Northern LTMA Region Airspace Change (OFJES, CLN CTA11/12, FL105+)

Gateway Documentation:
Stage 1 Define
Engagement Evidence
ACP-2025-023

Issue 1.0

Proposal seeking feedback

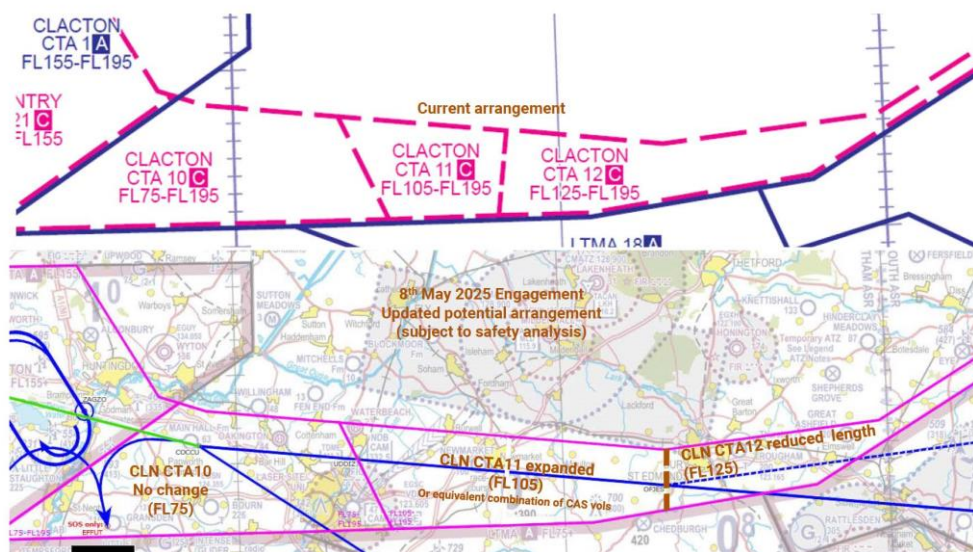
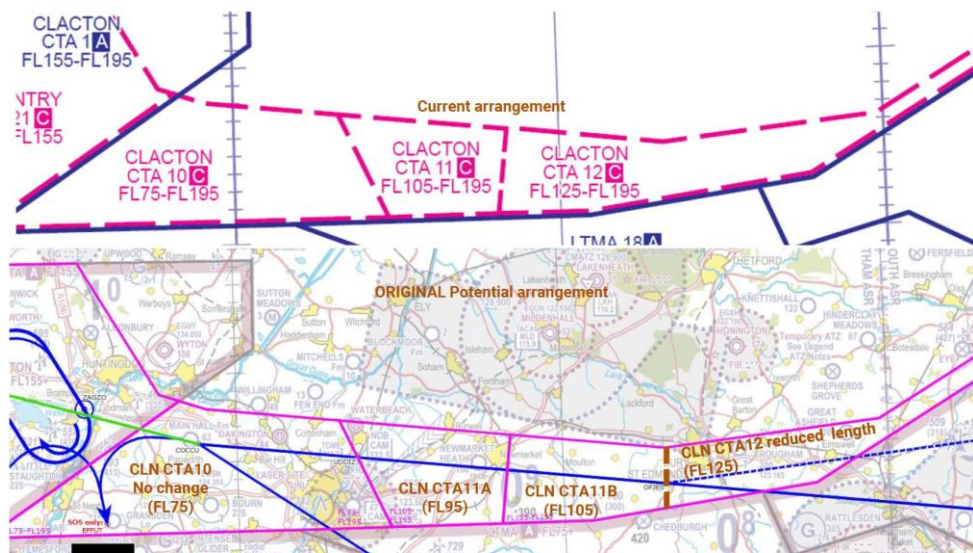
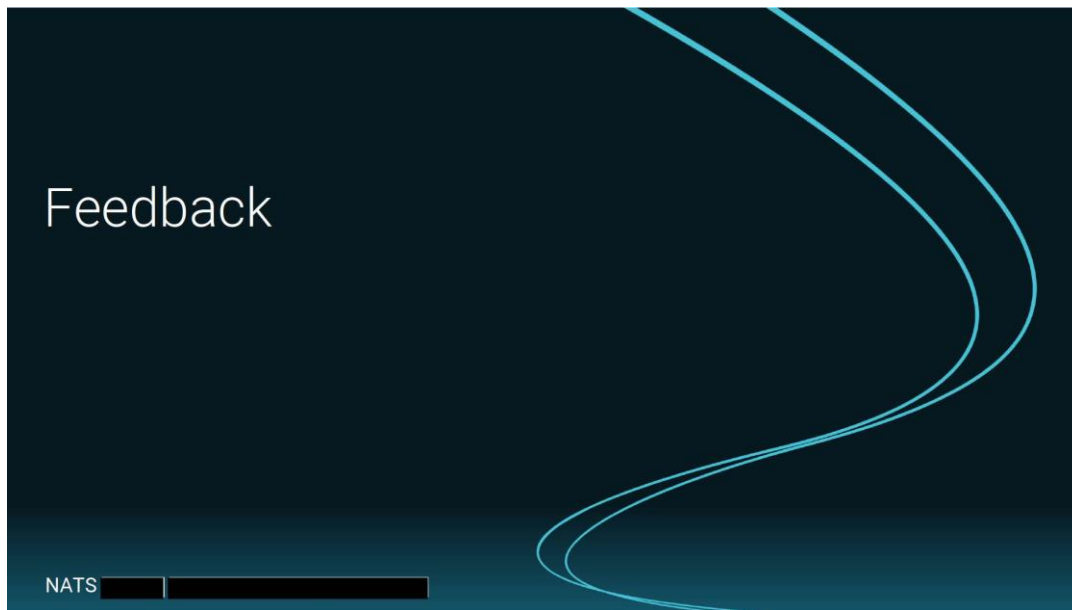
discussed the RAPCON operation and CAS options. The consensus was that dropping the base of CTA11 to FL95, as originally-considered, would likely cause significant adverse impacts on RAPCON, especially under easterly PFO exercises. Expanding the FL105 base of CTA11 eastwards, with a corresponding reduction in CLN CTA12, may cause impacts of a less significant nature, in effect reducing RAPCON's "headroom" when operating above high-flying General Aviation such as gliders, but with less impact on PFO and other ops.

The consensus was that dropping the base of CTA11 to FL95, as originally-considered, would likely cause significant adverse impacts on RAPCON, especially under easterly PFO exercises. Expanding the FL105 base of CTA11 eastwards, with a corresponding reduction in CLN CTA12, may cause impacts of a less significant nature, in effect reducing RAPCON's "headroom" when operating above high-flying General Aviation such as gliders, but with less impact on PFO and other ops

- Extend the existing FL105 base of Clacton CTA11 east to OFJES – circa 9nm

- Lowering the **existing** lateral boundary of Clacton CTA11 by 1,000ft to FL95
